ORIGINATION FORM

Proposed Revisions to a Standard Plans Index
(Please provide all information — Incomplete forms will be returned)

Index Number: 521-650
Sheet Number (s): 1
Index Title: Light Pole Pedestal - Wall Coping

Summary of the changes:

INDEX 521-650	SHEET 1 of 3
-------------------------	------------------------

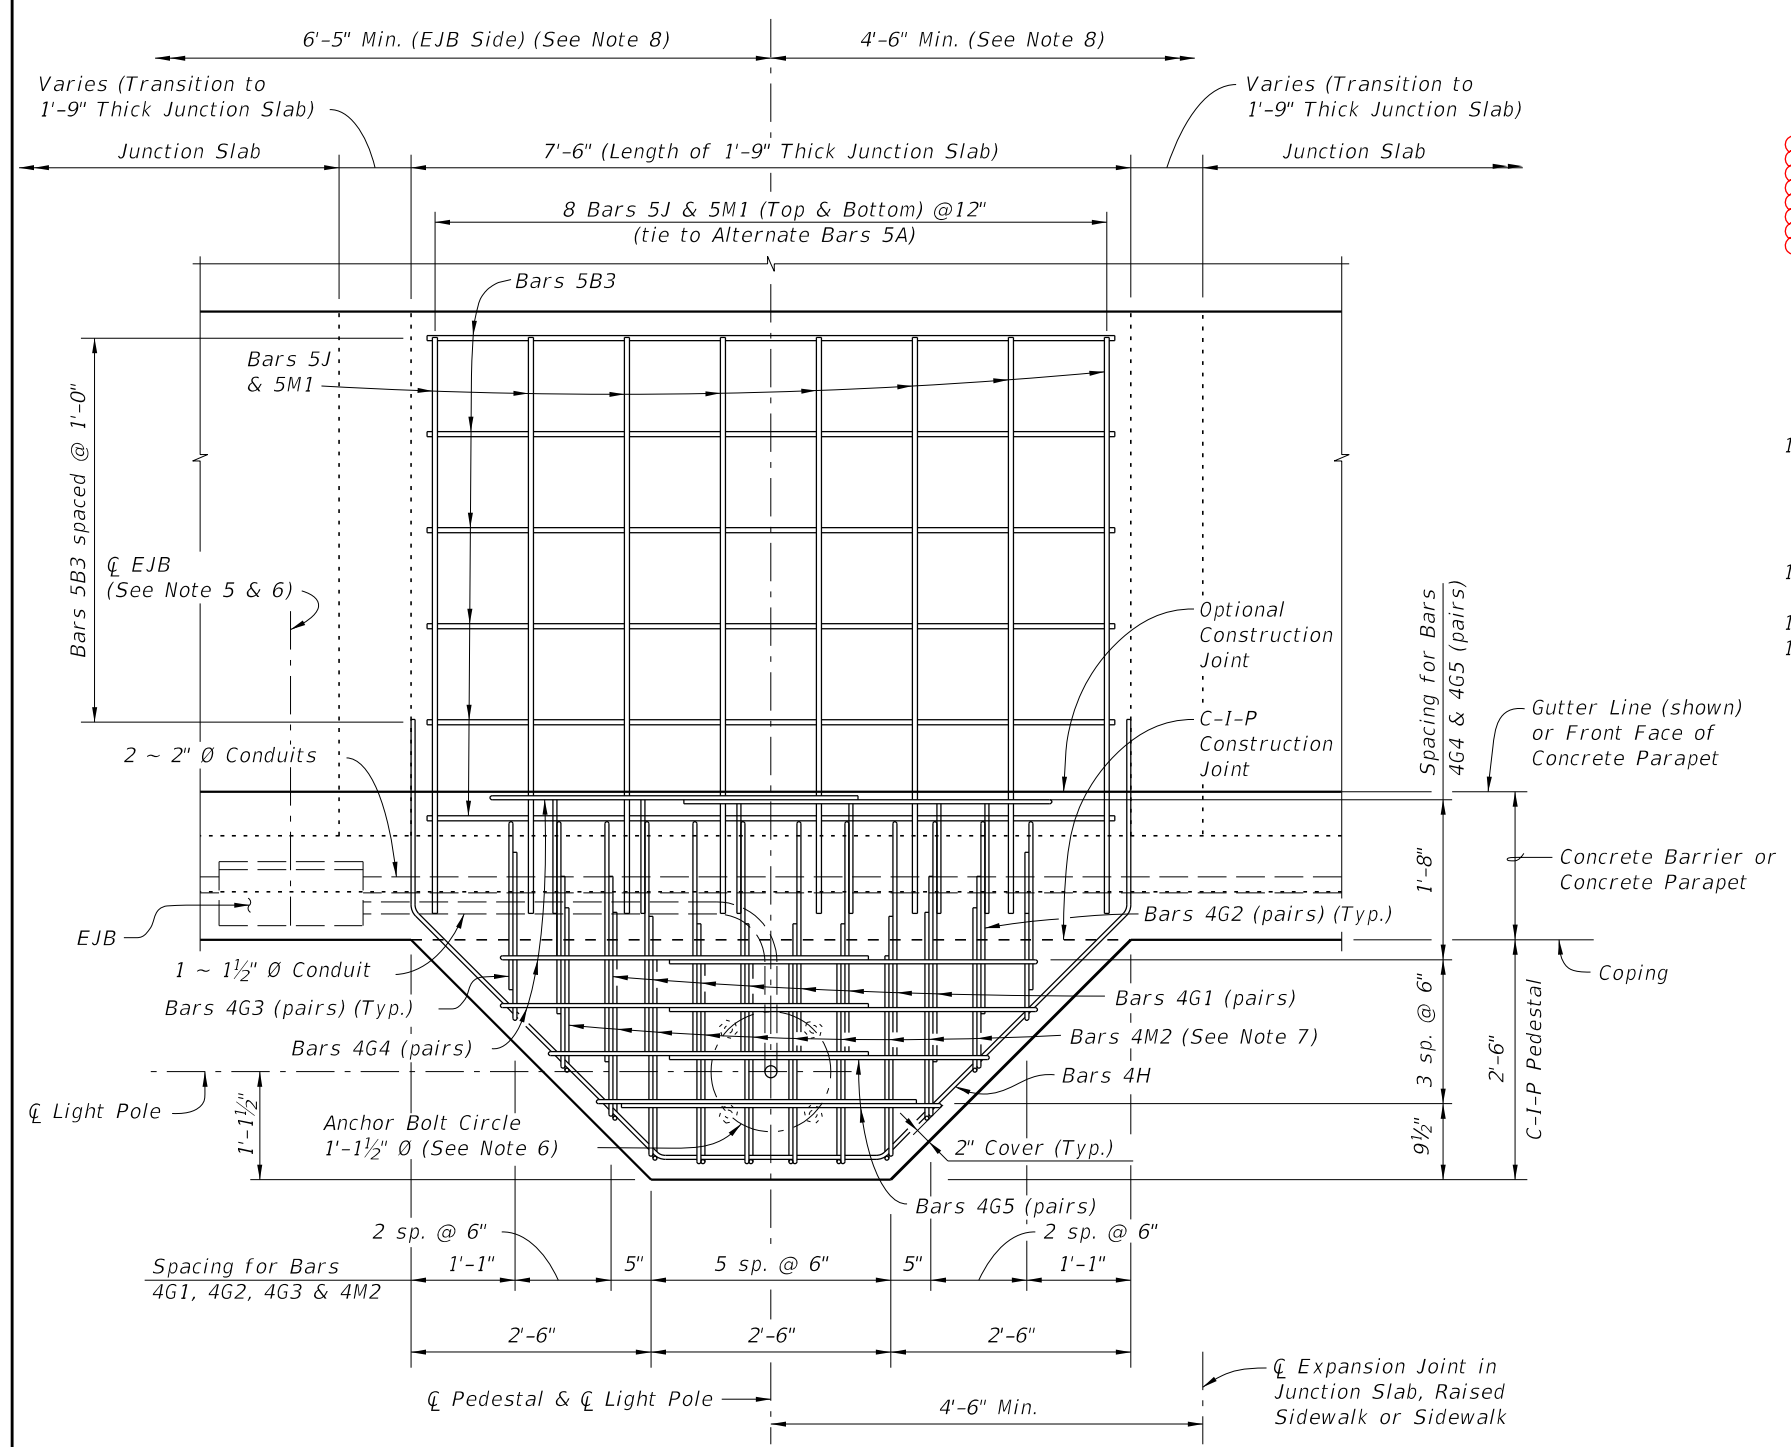
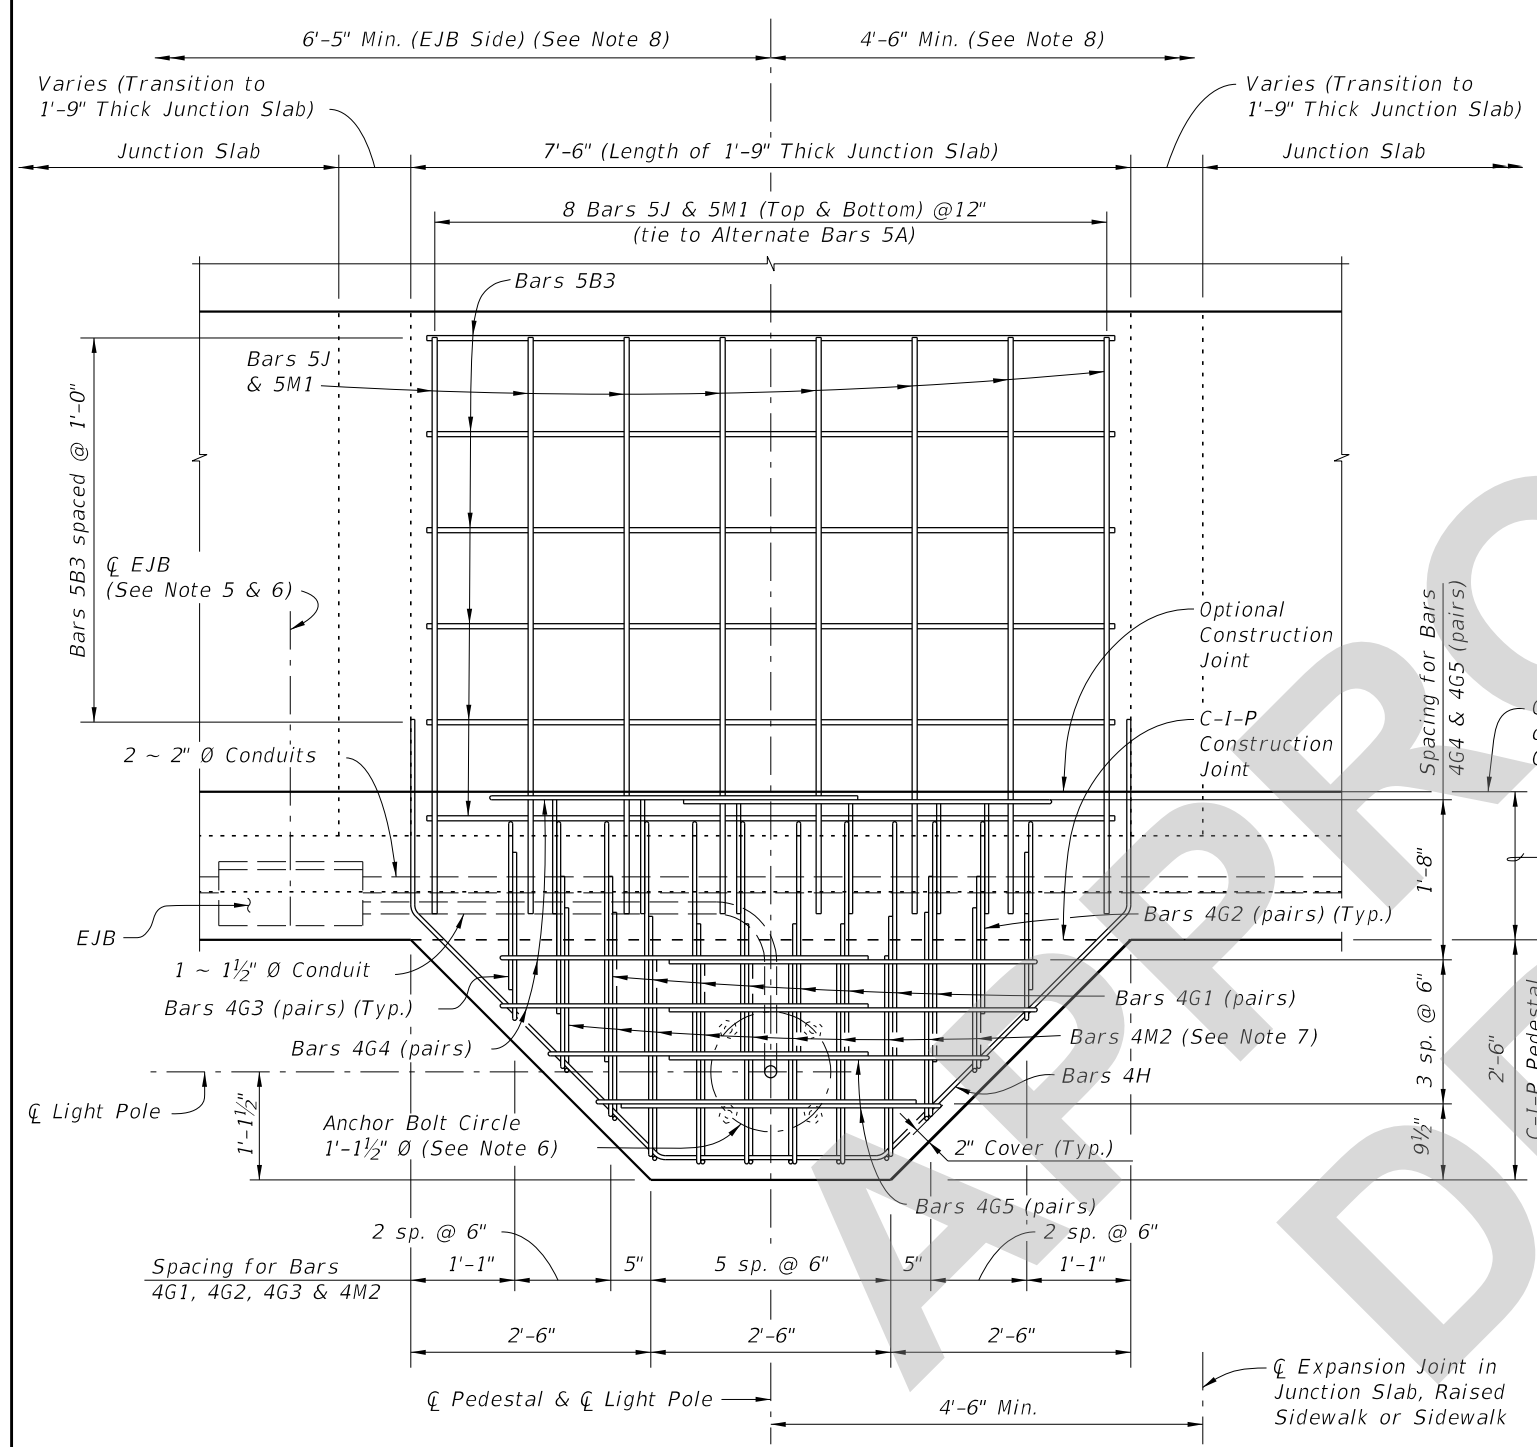
Sheet 1, Note 5: Added reference to Index 630-001 (Conduit Details - Embedded) for information on embedded junction boxes and conduits.

Added reference to provide continuity between Standards and improve understanding for designers and contractors wanting to verify that these Indexes share details. This particular topic received designer questions.

4. Install Anchor Bolts plumb.
5. For conduit, EJB and expansion/deflection fitting details, see Utility Conduit Detail Drawings and Index 630-010.
6. The cost of anchor bolts, nuts, washers and anchor plates will be included in the Bid Price for Light Poles. Include the cost of all labor, concrete and reinforcing steel required for construction of the pedestals, and miscellaneous hardware required for the completion of the electrical system in the Bid Price for either the Concrete Barrier or Concrete Parapet that the pedestal is behind.
